UNITED STATES PATENT AND TRADEMARK OFFICE

APPLICATION NO.	FILING DATE	FIRST NAMED INVENTOR	ATTORNEY DOCKET NO.	CONFIRMATION NO.
09/232,119	01/15/1999	THILO WEITZEL	298-73	2187

Office Action Summary

DETAILED ACTION

Fig. 2

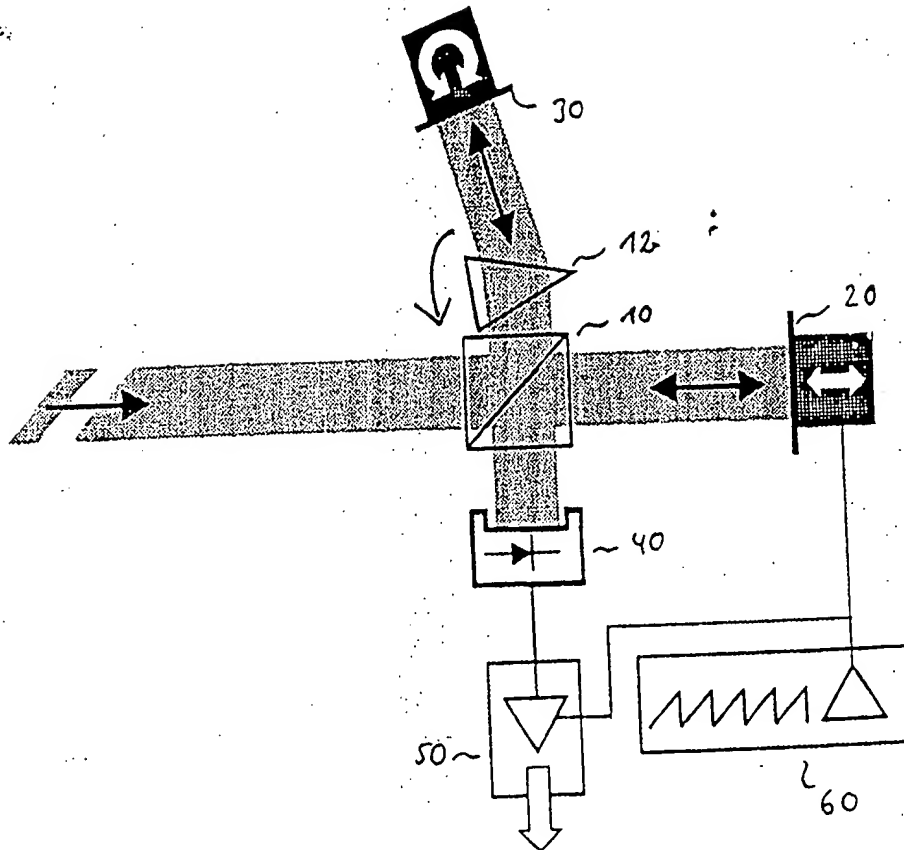
However, notice prism 12 in Applicant’s Fig. 2. According to the general understanding of prisms with such a shape, prism 12 would spatially separate optical channels of different wavelengths from each other. Then, after reflection from mirror 30, these channels would travel back through prism 12. However, due to the initial spatial separation of the optical channels and the angular relationship between prism 12 and mirror 30, any single, detected, optical channel with a defined wavelength would be spatially separated from other optical channels of different wavelengths. Thus, the disclosure does not teach this “without spatial separation” limitation.

Additionally, this “without spatial separation” limitation is not enabled by the disclosure. It appears that the “detection of a single optical channel with defined wavelength” depends on these features of Applicant’s invention: the initial spatial separation of the optical channels and the angular relationship between prism 12 and mirror 30. That is, the “detection” feature of Applicant’s invention ***depends***, at least, on spatial separation of the optical channels. Thus, there is conflict between this operating principle (the spatial separation) of Applicant’s invention in Fig. 2 and the “without spatial separation” language of

Notice that claims 54-55 include “**heterodyne**” detection. However, the discussion of the embodiment of Fig. 2 (e.g., p. 10, 1st paragraph) does not expressly disclose “heterodyne” detection. Consideration of the technical aspects of Applicant’s Fig. 2 leads one to wonder whether or not Applicant’s Fig. 2 actually involves “heterodyne” detection.

Next, let us consider Applicant’s apparatus in Fig. 2. It appears that Applicant’s apparatus in Fig. 2 functions by arranging the mixing, or interference, two electromagnetic waves: (1) the reference light from mirror 20 and (2) a particular portion (i.e., wavelength/frequency) of the spectrum of the light from mirror 30. The reference light has a frequency spectrum that is relatively broadband. The light from mirror 30 has the same spectral (frequency) components as the reference light and is also broadband. However, the particular arrangement of mirror 30 and prism 12 arranges the relevant interference of only a particular portion (i.e., wavelength) of the spectrum of the light from mirror 30 with the broadband spectrum of the reference light. Note that the wavelength of this particular portion (i.e., wavelength) of the spectrum of the light from mirror 30 is **included** in the broadband spectrum of the reference light.

Generally speaking, the “different wavelengths/frequencies” employed in “heterodyne” detection implies that the wavelength/frequency of one wave is **mutually exclusive** of the wavelength/frequency of the other wave. Under this reading of “different wavelengths/frequencies”, Applicant’s apparatus in Fig. 2 does not disclose “heterodyne” detection.

Approved by DSK
26 January 2006

As a simple remedy, Examiner respectfully suggests the simple removal of this “heterodyne” term and avoidance of the term “homodyne” to avoid all of these 35 U.S.C. 112 issues.

Fig. 5, showing the coupler

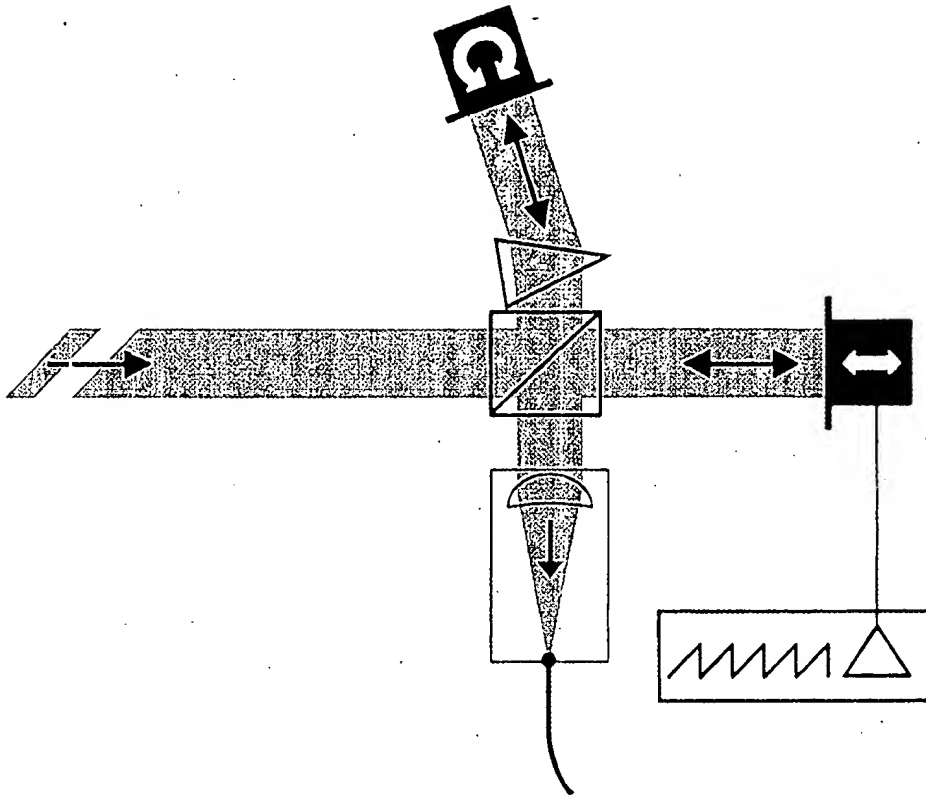
2. Applicant's compliance with the objections to the drawings in the previous Office Action (mailed on 17 May 2005) is noted and appreciated. A replacement drawing sheet for Fig. 2 and a new sheet for Fig. 5 were received on 21 November 2005. Fig. 2 is approved. Fig. 5 is disapproved. Fig. 5 shows structural details of a coupler and a fiber, but these structural details and this fiber is not taught in the disclosure. As a remedy, Examiner respectfully suggests replacing the coupler and fiber of this Fig. 5 with a generic box indicating the coupler in replacement drawing sheet for Fig. 5.

Disapproved by DSK

4. Corrected drawing sheets in compliance with 37 CFR 1.121(d) are required in reply to the Office action to avoid abandonment of the application. Any amended replacement drawing sheet should include all of the figures appearing on the immediate prior version of the sheet, even if only one figure is being amended. The figure or figure number of an amended drawing should not be labeled as "amended." If a drawing figure is to be canceled, the appropriate figure must be removed from the replacement sheet, and where necessary, the remaining figures must be renumbered and appropriate changes made to the brief description of the several views of the drawings for consistency. Additional replacement sheets may be necessary to show the renumbering of the remaining figures. Each drawing sheet submitted after the filing date of an application must be labeled in the top margin as either "Replacement Sheet" or "New Sheet" pursuant to 37 CFR 1.121(d). If the changes are not accepted by the examiner, the applicant will be notified and informed of any required corrective action in the next Office action. The objection to the drawings will not be held in abeyance.
